# Coastal Access Variation Report VR1

## Proposed Changes to the England Coast Path at Dunball Wharf and St Audries Bay, Somerset

Natural England's Variation Report to the Secretary of State  
24 September 2015

**Relevant Maps:** VR1- Map 1

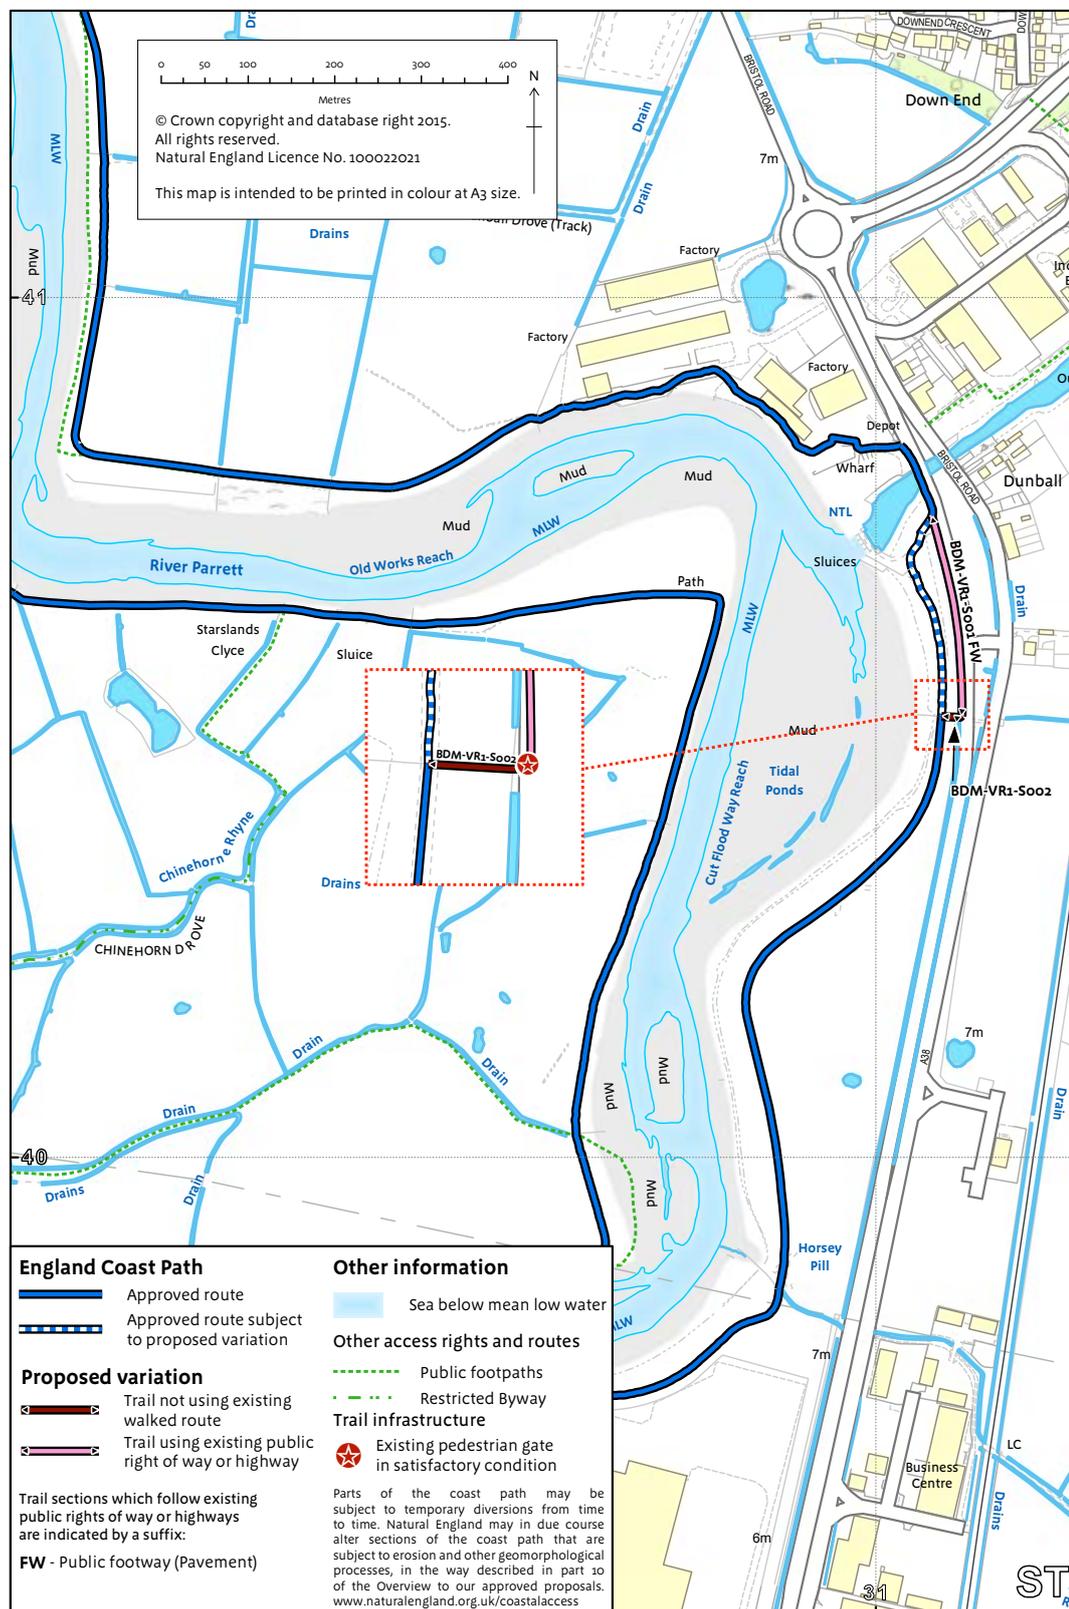
The approved route of the England Coast Path would install the England Coast Path along an existing public footpath through the working area of Dunball Wharf (see VR1- Map 1).

However, since this alignment was approved, the Environment Agency has determined that it is necessary to install new flood management facilities at the wharf. As a consequence, the route of the England Coast Path needs to be realigned to avoid the new installation and its curtilage.

Our proposal (see VR1- Map 1) is to re-route the path around the new flood management facilities by taking it further along the pavement (route section BMD-VR1-S001) to a new access point into the field to the south (route section BDM-VR1-S002) where the path would continue along the existing flood bank as originally approved.

As a consequence of these proposed changes, all land seaward of the trail would become part of the coastal margin. However the new flood management facility is secured by fencing and gates and will not be available for public access.

<b>Start Point:</b>	<b>Esson's Gully</b> (grid reference: ST120437)
<b>End Point:</b>	<b>St Audries Bay</b> (grid reference: ST115433)
<b>Relevant Maps:</b>	<b>VR1- Map 2</b>

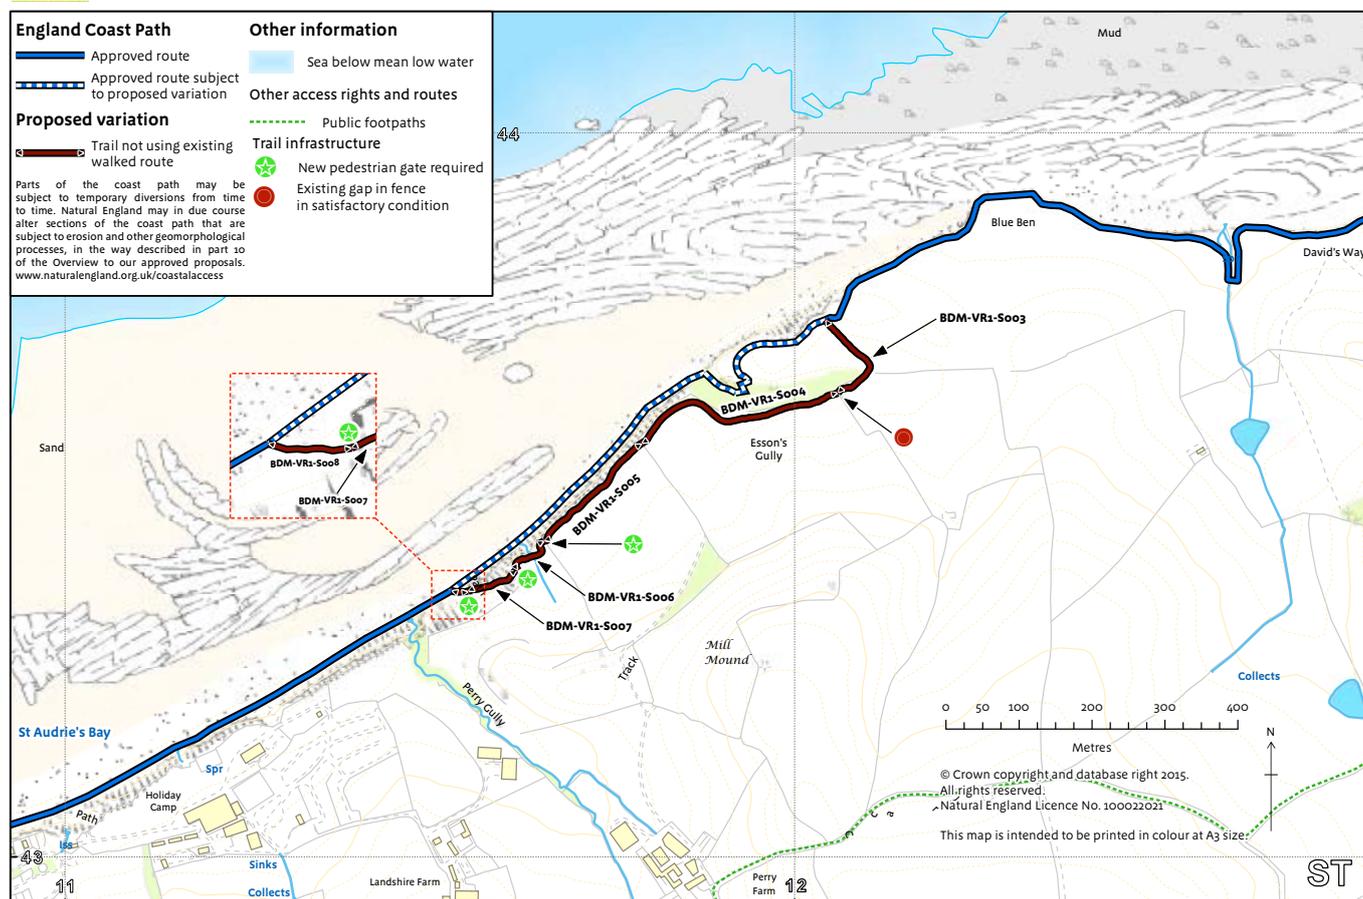
The approved route of the England Coast Path follows an existing walked route west along the cliff top from Quantock's Head to David's Way, after which it comprises a new access route further along the cliff top as far as Essons Gully. At Essons Gully it descends the gully to the beach at St Audries Bay, where it continues westwards along the beach – see VR1- Map 2. The approved report set out the reasons at the time for proposing that the route should descend to the beach at this point via Essons Gully.

The descent at Essons Gully from the cliff top to the beach has proved much more difficult to establish than was envisaged at the time the proposals were put forward. Initial exploratory works by the land owner had suggested that the route was viable but subsequent erosion during the major winter storms of 2014/15 caused unexpected damage that compromised the original means of descent. Engineers conducted detailed investigations and advised that installation of steps would be the most cost efficient means of providing a descent to the beach at this point, with an estimated cost of £145,000. The tenant then came forward with an alternative, more cost-effective route proposal which would avoid the need for a descent at Essons Gully, as described below.

Our proposal is to re-route the trail along the cliff top landward of Esson's Gully and westwards to the top of a cliff slope located just east of Perry Gully as shown on VR1- Map 2. At this point the route would descend the slope where it would re-join the approved route and continue westwards along the beach at St Audries Bay.

As a consequence of these changes, areas of cliff that are seaward of the newly proposed route would become part of the coastal margin. There would be no additional areas of spreading room to the landward side of the trail.
